**Flood Control Project Maintenance
Levee Inspections**
LMA District Cover Sheet
Spring 2018 Levee Inspection Results

Sutter Maintenance Yard Maintenance Area 0001

Levee Inspection Report By Mile - Spring 2018

Photo 1 of 3 : UCIP_SP_2018_51865_70144.jpg

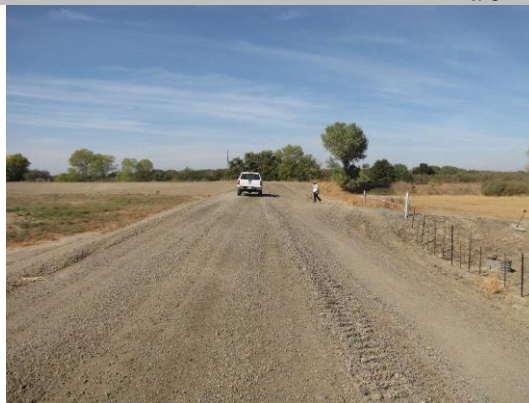
Comment Code						
Inspector Comment						
FS_ID:51865 DS_ID:16421 EP_NO: 9475 Repair Type: Non-Urgent Crossing Status: Found UCIP Comments: 5/3/2017 Abandoned- only WS standpipe visible. (DWR Sutter Yard- A Freitag)10/24/2016 Appears to be abandoned.(DWR Sutter Yard- A Freitag)4/25/2016 Abandoned crossing. Only WS standpipe is visible.4/20/2015 Same as last inspection.6/18/2014 Same as last inspection.12/17/2013 Same as last inspection.7/18/2013 Same as last inspection.10/19/2012 Burrow activity; limited visibility of this crossing only on WS riser. This crossing was listed in the USACE Periodic Inspection as ID# USACE_CESPK_MA1C_2010_p_0207 the wheel to operate sluice gate missing. Issue addressed wheel to slide gate has been installed. FIELD_STRUCT_DESC: *ABANDONED* 30-inch corrugated metal irrigation pipe through the levee, 16.1 feet below the crown. Slide gate inside corrugated metal pipe (CMP) riser located on the waterside (WS) end. Line buried on the WS and landside (LS). (Automatic Board Order (ABO) issued as Permit No. 9475, 1974 - Mattie B. Zumwalt Co.) [Additional Reference(s): DWR Levee Log, 1992. USACE Sacramento O&M Manual 137, August 1955, (Station 247+86)]. FS Date: 5/23/2017 9:39:55 AM

Photo 1 of 3 : UCIP_SP_2018_51889_70267.jpg

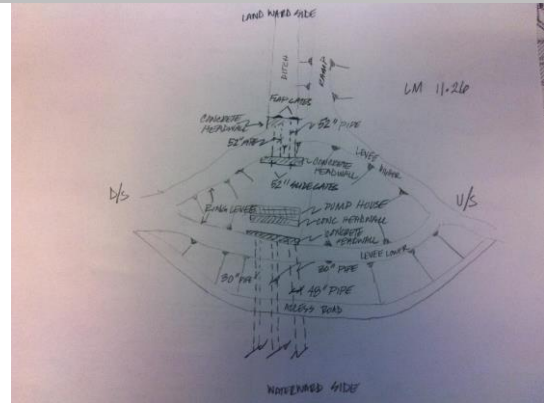
FS_ID:51889
DS_ID:16449
EP_NO: 187
Repair Type: Non-Urgent
Crossing Status: Found
UCIP Comments: 5/3/2017 No changes have been made to this crossing since the NOV was sent out in January 2017. (DWR Sutter Yard- A Freitag)01/31/2017 Informal Notice of Violation (NOV) was sent out January 31, 2017 by DWR Flood Maintenance Office--owner will need to coordinate with CVFPB to remove, replace, or abandon pipe in-place. Owner has until Monday February 27th, 2017 to respond to DWR contact: Bryan Reniff. (refer to Official Notice for details). (DWR UCIP - O. Magana)10/24/2016 Appears abandoned. Slide gate needs to be dug out and fully closed to prevent water flow during high water.(DWR Sutter Yard- A Freitag)4/25/2016 Crossing appears to be abandoned.4/21/2015 Same as last inspection.6/23/2014 Same as last inspection.12/17/2013 Same as last inspection.7/18/2013 Same as last inspection.10/30/2012 Need to determine if structure is still in use--contact owner. If abandoned structure--structure needs to be properly abandoned. This crossing was listed in the USACE Periodic Inspections as ID# USACE_CESPK_MA1C_2010_p_0393 missing gate. FIELD_STRUCT_DESC: 1 of 2: 52-inch corrugated metal irrigation pipe, 48-inch measured, through the levee, approximately 15 feet below the crown. Slide gate on the waterside (WS) and flap gate on the landside (LS). Concrete headwalls at both WS and LS. This structure is associated with another abandoned structure located on the WS. Abandoned structure includes pump house, multiple concrete walls, and 3 additional crossings (two 30-inch pipes and one 48-inch pipe). (Original structure installed under Permit No. 187, 1921 - Compton-Delevan Irrigation District-Maxwell I.D., new pump and platform installed and old pump house removed under Permit No. 9183-1973, Maxwell Irrigation District) [Additional Reference(s): DWR Levee Log, 1992].

FS_ID:51889
DS_ID:16449
EP_NO: 187
Repair Type: Non-Urgent
Crossing Status: Found
UCIP Comments: 5/3/2017 No changes have been made to this crossing since the NOV was sent out in January 2017. (DWR Sutter Yard- A Freitag)01/31/2017 Informal Notice of Violation (NOV) was sent out January 31, 2017 by DWR Flood Maintenance Office--owner will need to coordinate with CVFPB to remove, replace, or abandon pipe in-place. Owner has until Monday February 27th, 2017 to respond to DWR contact: Bryan Reniff. (refer to Official Notice for details). (DWR UCIP - O. Magana)10/24/2016 Appears abandoned. Slide gate needs to be dug out and fully closed to prevent water flow during high water.(DWR Sutter Yard- A Freitag)4/25/2016 Crossing appears to be abandoned.4/21/2015 Same as last inspection.6/23/2014 Same as last inspection.12/17/2013 Same as last inspection.7/18/2013 Same as last inspection.10/30/2012 Need to determine if structure is still in use--contact owner. If abandoned structure--structure needs to be properly abandoned. This crossing was listed in the USACE Periodic Inspections as ID# USACE_CESPK_MA1C_2010_p_0393 missing gate. FIELD_STRUCT_DESC: 1 of 2: 52-inch corrugated metal irrigation pipe, 48-inch measured, through the levee, approximately 15 feet below the crown. Slide gate on the waterside (WS) and flap gate on the landside (LS). Concrete headwalls at both WS and LS. This structure is associated with another abandoned structure located on the WS. Abandoned structure includes pump house, multiple concrete walls, and 3 additional crossings (two 30-inch pipes and one 48-inch pipe). (Original structure installed under Permit No. 187, 1921 - Compton-Delevan Irrigation District-Maxwell I.D., new pump and platform installed and old pump house removed under Permit No. 9183-1973, Maxwell Irrigation District) [Additional Reference(s): DWR Levee Log, 1992].

Photo 1 of 3 : UCIP_SP_2018_51891_70272.jpg

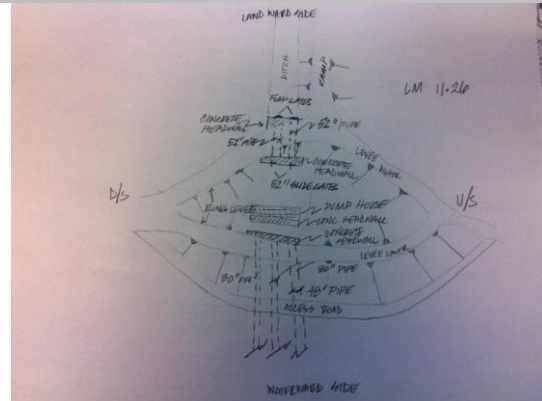
FS_ID:51891
DS_ID:17572
EP_NO: 187
Repair Type: Urgent
Crossing Status: Found
UCIP Comments: 5/3/2017 No changes have been made at this crossing since the NOV was sent out in January 2017. (DWR Sutter Yard- A Freitag)01/31/2017 Informal Notice of Violation (NOV) was sent out January 31, 2017 by DWR Flood Maintenance Office--owner will need to coordinate with CVFPB to remove, replace, or abandon pipe in-place. Owner has until Monday February 27th, 2017 to respond to DWR contact: Bryan Reniff. (refer to Official Notice for details). (DWR UCIP - O. Magana)10/24/2016 Appears abandoned. Slide gate needs to be replaced or pipe end capped to prevent water flow during high water. (DWR Sutter Yard- A Freitag)4/25/2016 Crossing appears to be abandoned. Slide gate needs to be replaced or pipe needs to be plugged to prevent water flow during high water season. (DWR Sutter Yard - a Freitag)4/21/2015 Same as last inspection. (DWR Sutter Yard - a Freitag)6/23/2014 Same as last inspection. (DWR Sutter Yard - a Freitag)12/17/2013 Same as last inspection. (DWR Sutter Yard - a Freitag)7/18/2013 Same as last inspection. (DWR Sutter Yard - a Freitag)10/30/2012 Missing positive closure device. Need to determine if structure is still in use--contact owner. If abandoned structure--structure needs to be abandoned properly. This crossing was listed in the USACE Periodic Inspections as ID# USACE_CESPK_MA1C_2010_p_0393 missing gate. (DWR UCIP - omagana)

FS_ID:51891
DS_ID:17572
EP_NO: 187
Repair Type: Urgent
Crossing Status: Found
UCIP Comments: 5/3/2017 No changes have been made at this crossing since the NOV was sent out in January 2017. (DWR Sutter Yard- A Freitag)01/31/2017 Informal Notice of Violation (NOV) was sent out January 31, 2017 by DWR Flood Maintenance Office--owner will need to coordinate with CVFPB to remove, replace, or abandon pipe in-place. Owner has until Monday February 27th, 2017 to respond to DWR contact: Bryan Reniff. (refer to Official Notice for details). (DWR UCIP - O. Magana)10/24/2016 Appears abandoned. Slide gate needs to be replaced or pipe end capped to prevent water flow during high water. (DWR Sutter Yard- A Freitag)4/25/2016 Crossing appears to be abandoned. Slide gate needs to be replaced or pipe needs to be plugged to prevent water flow during high water season. (DWR Sutter Yard - A Freitag)4/21/2015 Same as last inspection. (DWR Sutter Yard - A Freitag)6/23/2014 Same as last inspection. (DWR Sutter Yard - A Freitag)12/17/2013 Same as last inspection. (DWR Sutter Yard - A Freitag)7/18/2013 Same as last inspection. (DWR Sutter Yard - A Freitag)10/30/2012 Missing positive closure device. Need to determine if structure is still in use--contact owner. If abandoned structure--structure needs to be abandoned properly. This crossing was listed in the USACE Periodic Inspections as ID# USACE_CESPK_MA1C_2010_p_0393 missing gate. (DWR UCIP - O Magana)

Photo 1 of 3 : UCIP_SP_2018_51900_70342.jpg

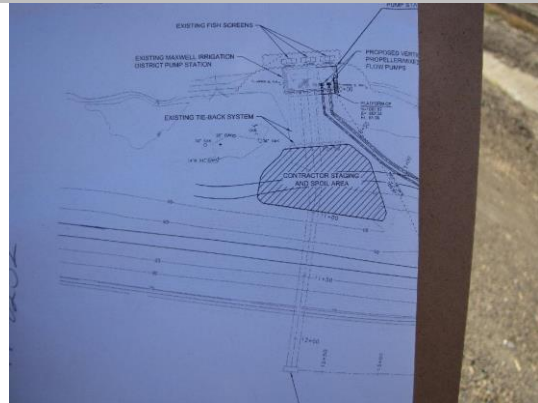
Comment Code						
Inspector Comment						
FS_ID:51900 DS_ID:20584 EP_NO: N/A Repair Type: Non-Urgent Crossing Status: Found UCIP Comments: 5/3/2017 Crossing appears to be in good condition. (DWR Sutter Yard- A Freitag)10/24/2016 appears to be in good condition.(DWR Sutter Yard- A Freitag)4/25/2016 Crossing appears to be in good condition.4/21/2015 Same as last inspection.6/23/2014 Same as last inspection.12/17/2013 Same as last inspection.7/22/2013 Same as last inspection.10/30/2012 Need to determine encroachment permit for this crossing. FIELD_STRUCT_DESC: [Maxwell Irrigation District] 3 of 3: 24-inch steel irrigation pipe through the levee at an unknown depth below the crown. Crossing is tied to existing Maxwell Irrigation District Pump Station located on the waterside (WS). Siphon breaker inside corrugated metal pipe (CMP) riser located on the landside (LS) shoulder. No permit has been identified since crossing was field discovered in 2012. FS Date: 5/23/2017 11:47:50 AM

Item	DWR UCIP Field Study			39.344400 °	39.344400 °	
				-122.031785 °	-122.031785 °	
DWR ID						
Comment Code						
Inspector Comment						
FS_ID:51900 DS_ID:20584 EP_NO: N/A Repair Type: Non-Urgent Crossing Status: Found UCIP Comments: 5/3/2017 Crossing appears to be in good condition. (DWR Sutter Yard- AFreitag)10/24/2016 appears to be in good condition.(DWR Sutter Yard- AFreitag)4/25/2016 Crossing appears to be in good condition.4/21/2015 Same as last inspection.6/23/2014 Same as last inspection.12/17/2013 Same as last inspection.7/22/2013 Same as last inspection.10/30/2012 Need to determine encroachment permit for this crossing. FIELD_STRUCT_DESC: [Maxwell Irrigation District] 3 of 3: 24-inch steel irrigation pipe through the levee at an unknown depth below the crown. Crossing is tied to existing Maxwell Irrigation District Pump Station located on the waterside (WS). Siphon breaker inside corrugated metal pipe (CMP) riser located on the landside (LS) shoulder. No permit has been identified since crossing was field discovered in 2012. FS Date: 5/23/2017 11:47:50 AM
